ADDENDUM NO. 1 FINAL CD DRAWINGS

Project: All Saints Catholic Church and School

Date: June 16, 2014

All Saints Church and School - Final Bid Package

SKETCH
MS-2

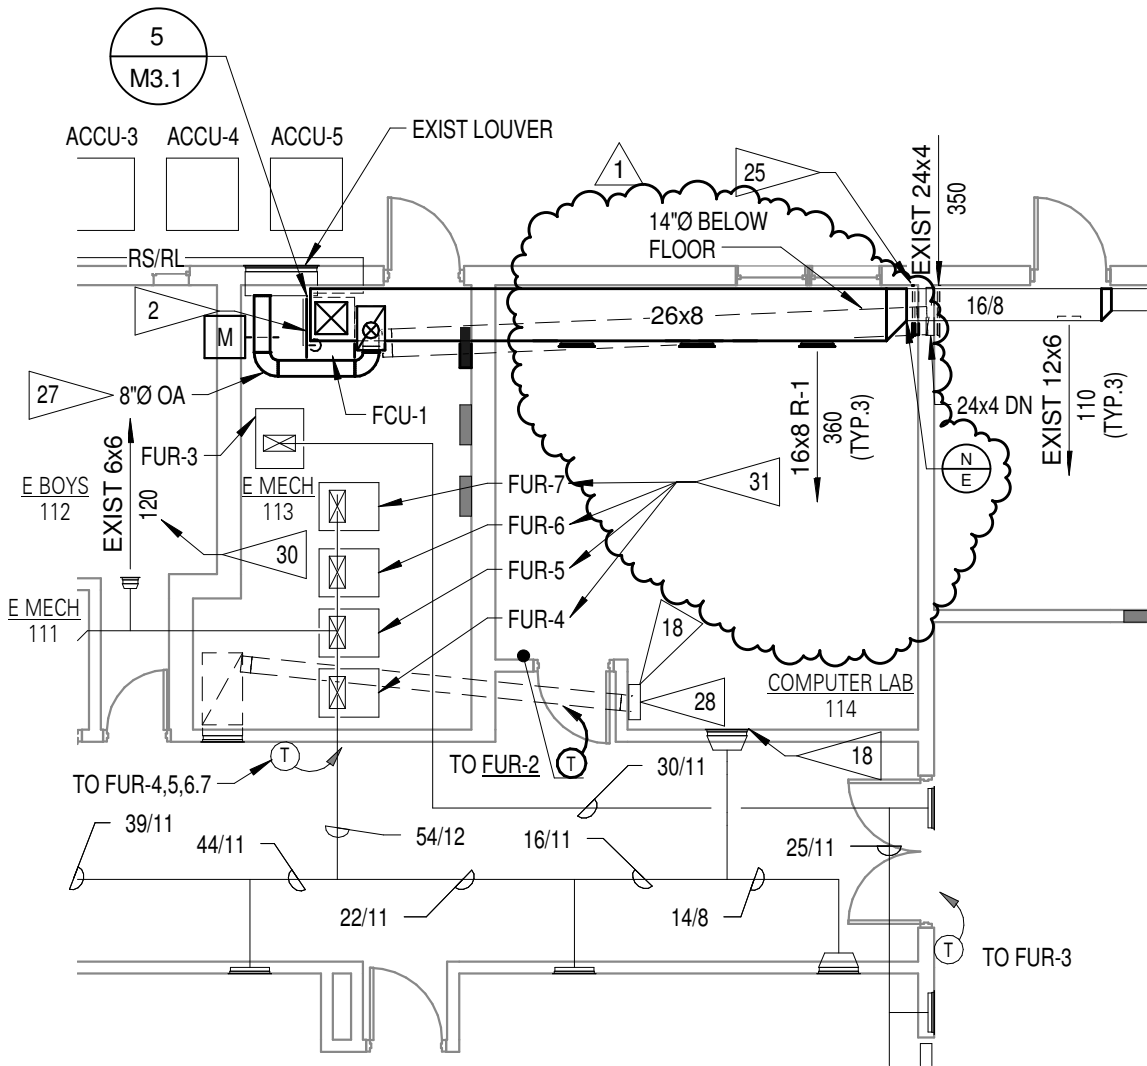
1. Revise the supply air ductwork and the refrigerant piping in Renovated Classroom 103 to allow for an exposed structure in the east part of this classroom as indicated on the attached Mechanical Sketch Sheet MS-2.
2. Relocate the Intake air Hood IH-1 to be at least 10'-0" away from the Furnace FUR-1 flue roof discharge location, per revised Flag Note No. 5, as indicated on the attached Mechanical Sketch Sheet MS-2.
3. Remove the new supply air ductwork, reuse the existing supply air sidewall registers, and revise the transfer air duct in Office 101 to allow for an exposed structure as indicated on the attached Mechanical Sketch Sheet MS-2.
4. Remove the new supply air branch ductwork and provide new sidewall registers in Computer Lab 114 to allow for an exposed structure as indicated on the attached Mechanical Sketch Sheet MS-3.
5. Revise Flag Note No. 33 to read as follows:

1 5 OA INTAKE HOOD MOUNTED ON ROOF. LOCATE HOOD AT LEAST 10'-0" CLEAR OF FURNACE FLUE LOCATION.

| PROJECT NO. | DATE | DRAWING REFERENCED: | E0.1 | SKETCH ES-1 |

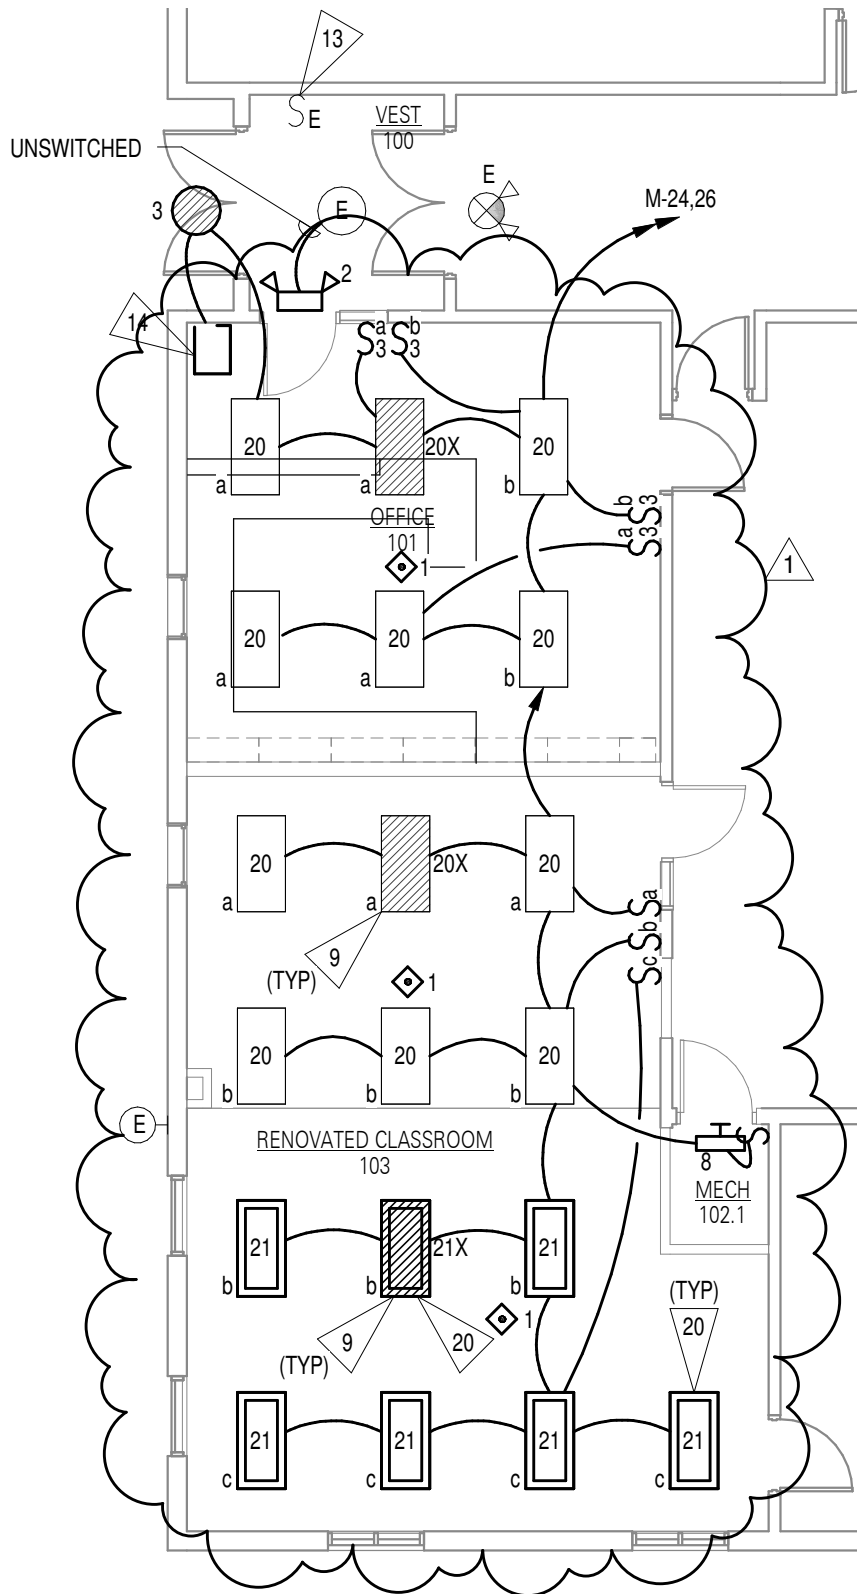
1. Revise the lighting demolition for the existing church office as indicated on the attached Electrical Sketch Sheet ES-1.

**ALL SAINTS CHURCH AND SCHOOL
ADD 1 FINAL BID PKG ATTACH. A**

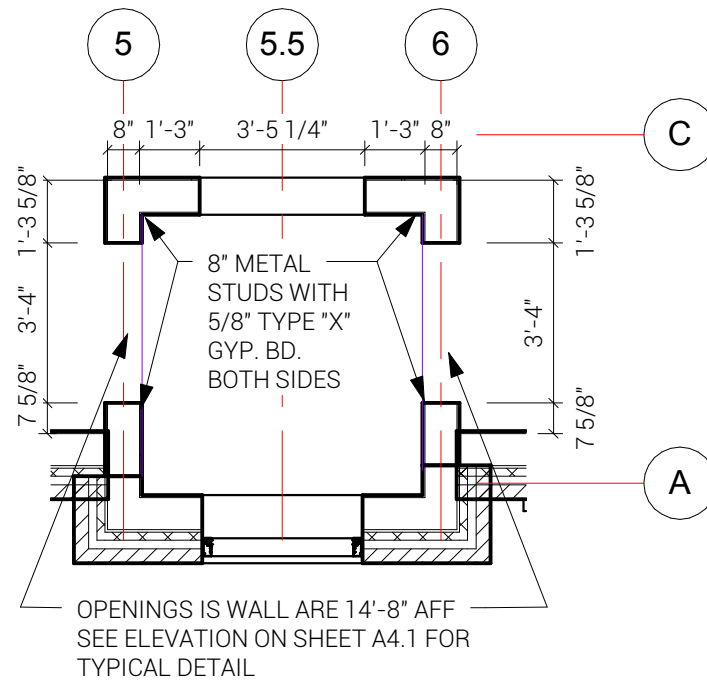
- A. Sheet A1.1 – FIRST FLOOR PLAN AND DOOR SCHEDULE
 - 1. Vestibule 100 door types change from existing doors to new doors, see attachment A.
- B. Sheet A1.1 - ENLARGED FLOOR PLAN - RESTROOM
 - 1. See attachment B for clarification on toilet accessories.

**ALL SAINTS CHURCH AND SCHOOL
ADD 1 FINAL BID PKG ATTACH. C**

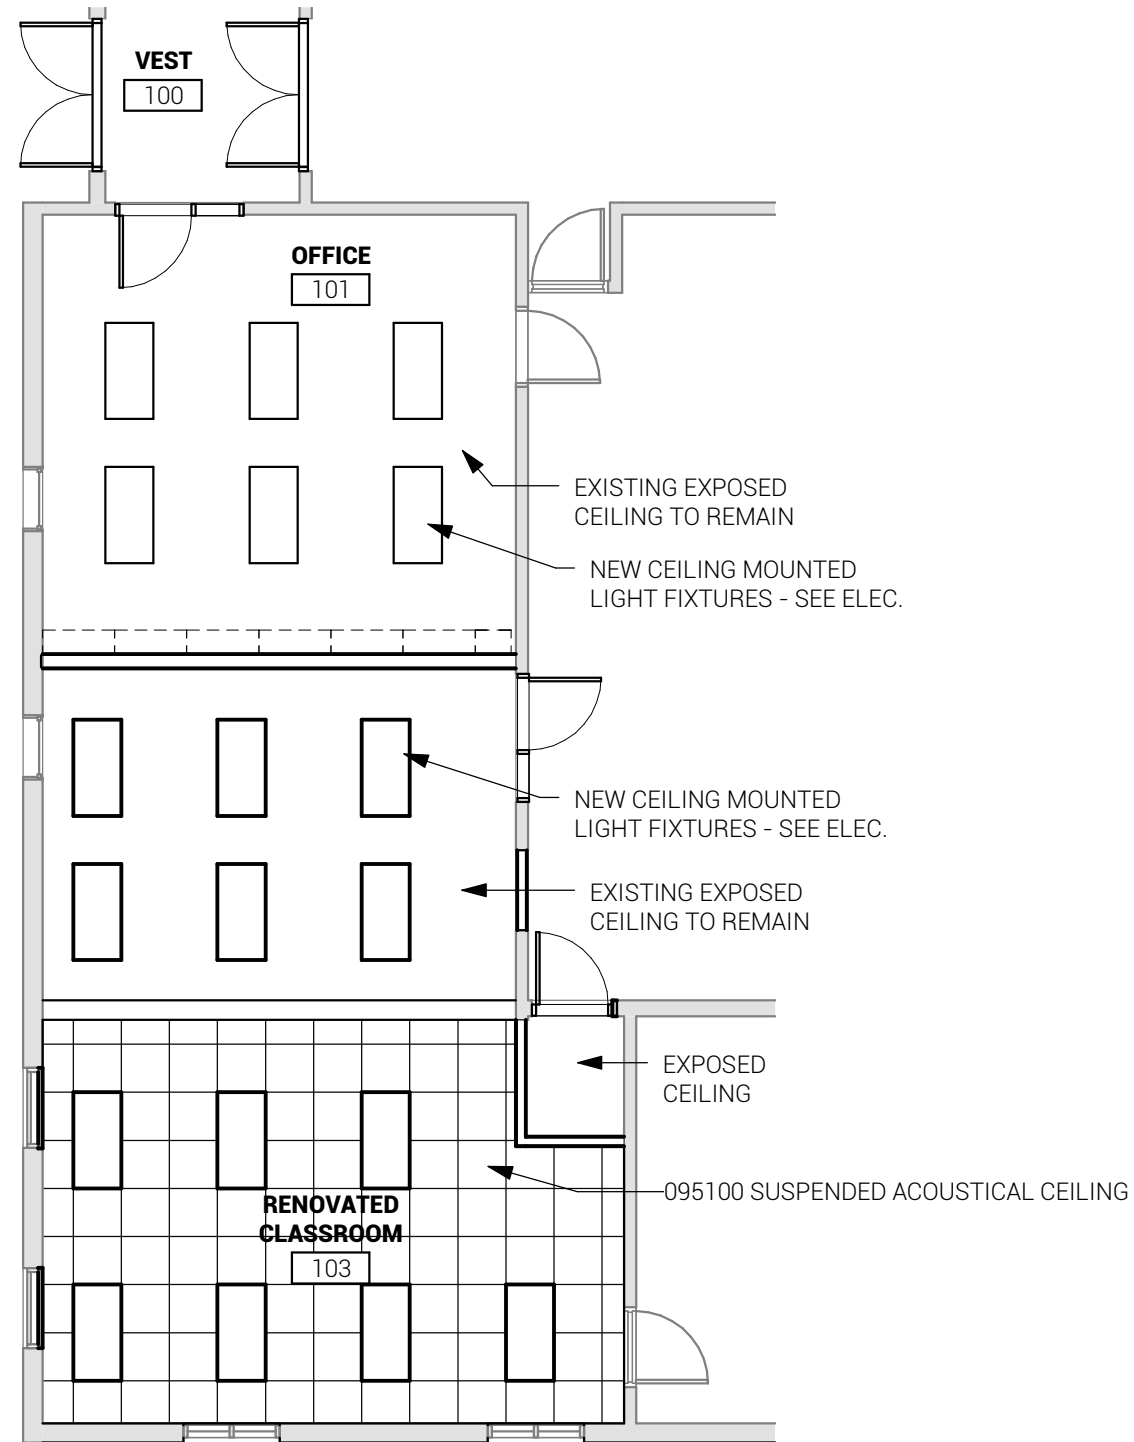
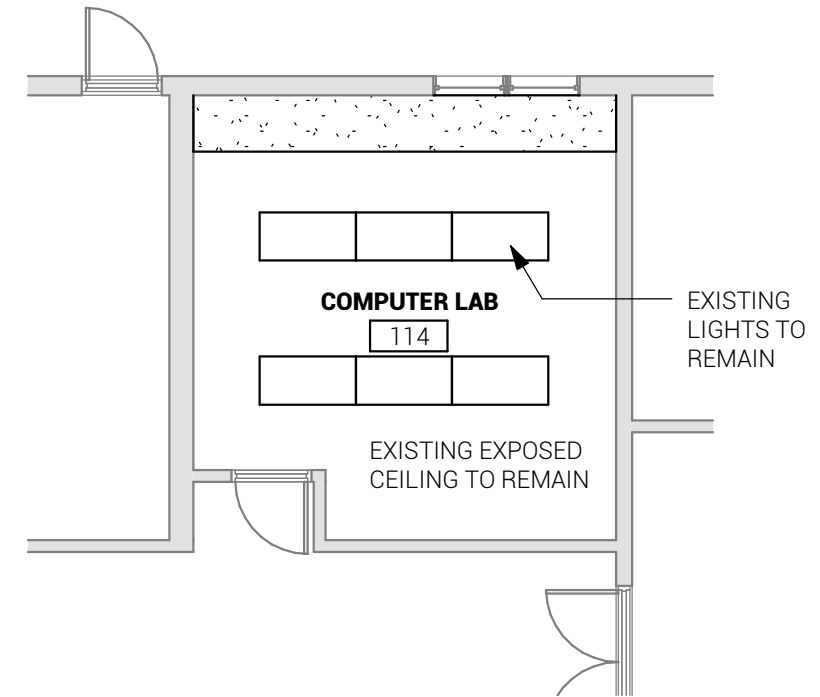
1. Remove new ceilings in Computer Lab 114, Office 101, and a portion of Renovated Classroom 103. See attachment C

| PROJECT NO. 20133925 | DATE 06/16/2014 | DRAWING REFERENCED: M3.1 | SKETCH MS-4 |

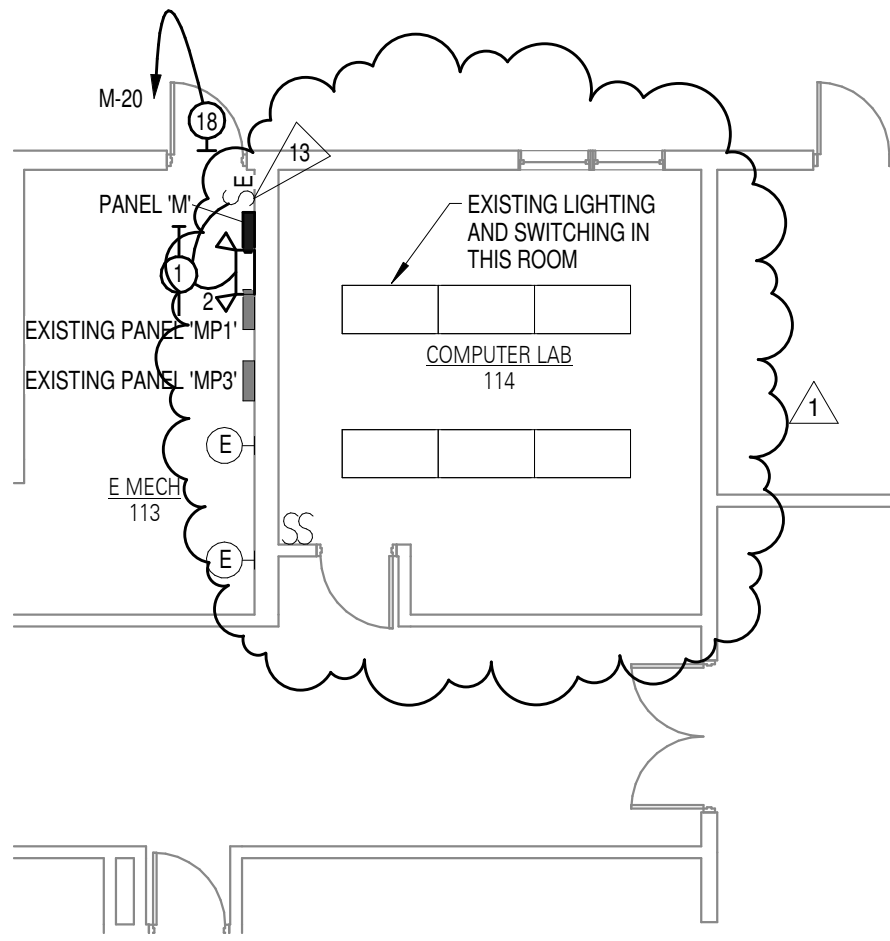
1. Revise Detail 5/M3.1 – Fan Coil Unit Detail – FCU-1 as follows:
 - A. Remove the second condensate trap and drain from the FCU-1 casing.
2. Revised Detail 13/M3.1 – Gas Water Heater with Circulation Pump as follows:
 - A. Revise the location of the HWCP-1 strainer as indicated on the attached Mechanical Sketch Sheet MS-4.

| PROJECT NO. | DATE | DRAWING REFERENCED: | E2.1 | SKETCH ES-4 |

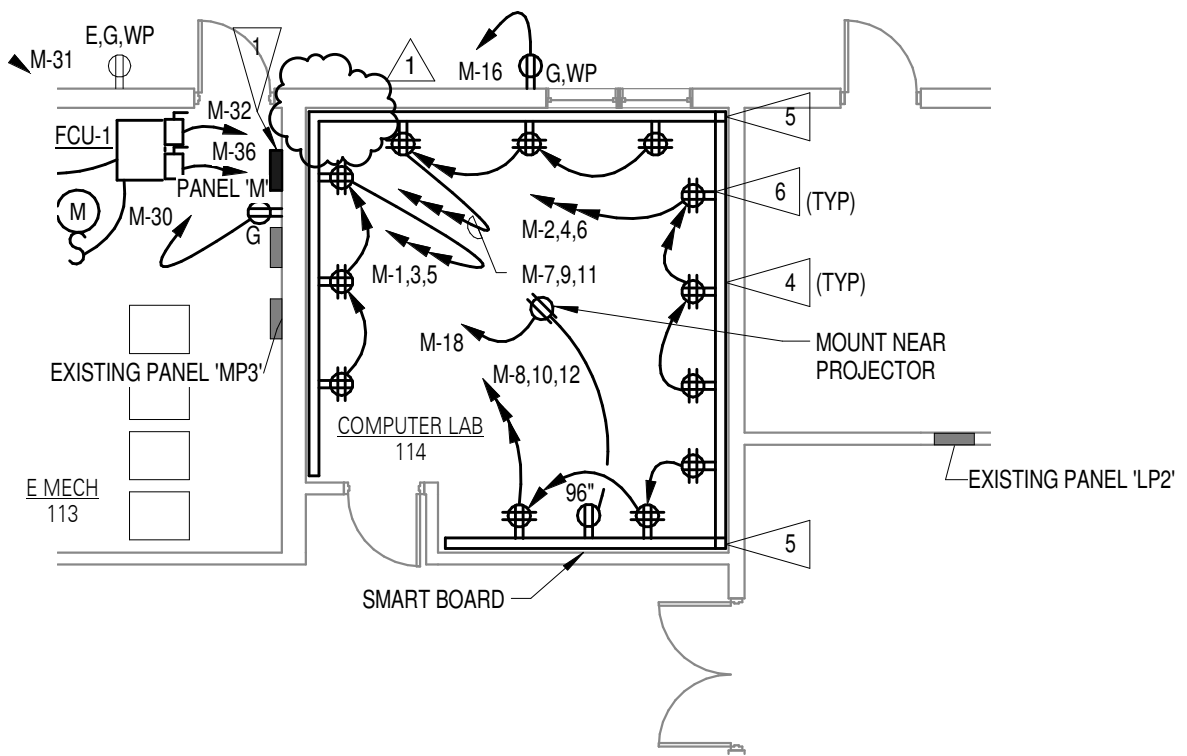
1. Revise the power for Office 101 as indicated on the attached Electrical Sketch Sheet ES-4.
